August 31, 2023

**Re: University View Apartments
Lot 001 Block 8 Volcano Cliffs
Traffic Circulation Layout**
Architect's Stamp 08-11-23 (C09-D016B)

Based upon the information provided in your submittal received 08-21-23, the above referenced plan cannot be approved for Building Permit until the following comments are addressed:

SITE PLAN
SCALE: 1" = 40'-0"

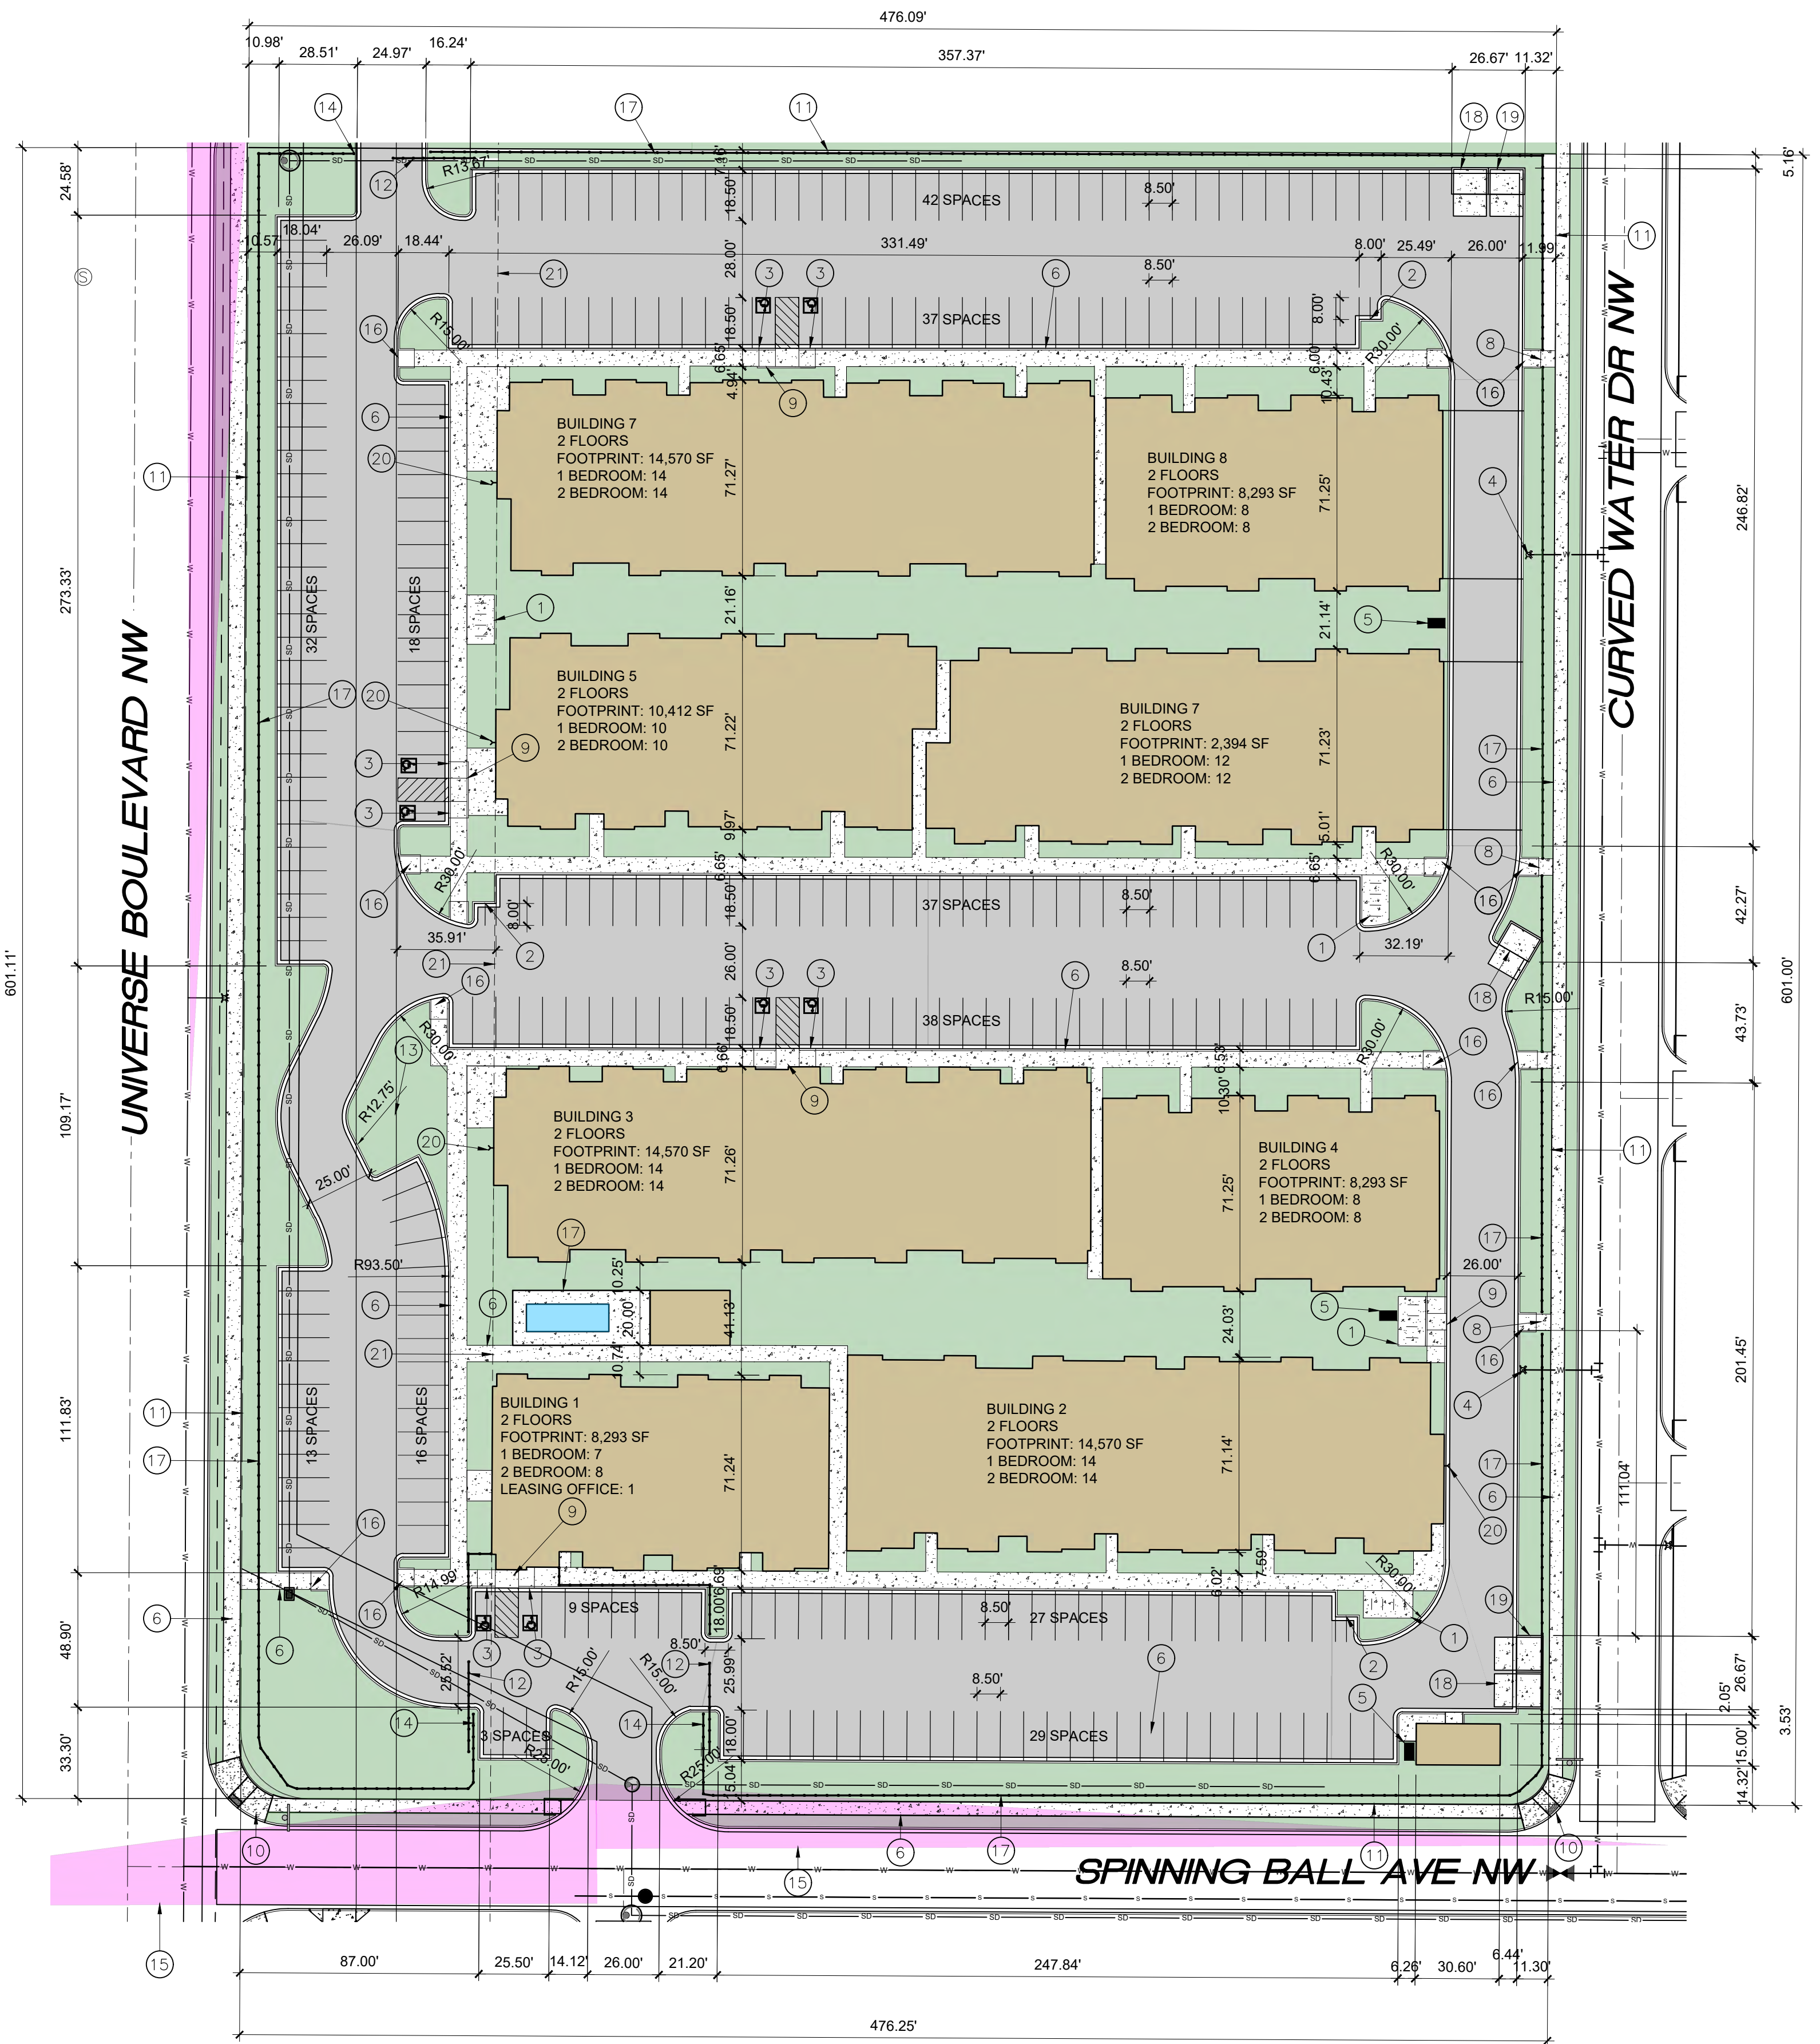
1. Identify all existing access easements and rights of way width dimensions.
2. Identify the right of way width, medians, curb cuts, and street widths on Universe Blvd, Spinning Ball Ave, and Curved Water Dr.
3. Provide site access design details, or reference COA std dwg.
4. Please provide Infrastructure list.
5. Please show on the site plan the City right of way improvement that required by Engineer Matt Grush.
6. Please provide approved plat or shared access agreement with the northside property.
7. Provide a copy of Fire Marshal and Solid Waste approval.
8. The pavement marking "MC" should be shown in the opposite direction for motorcycles entering the parking space.
9. Please provide Legend on the site plan.
10. Please provide a letter of response for all comments given.
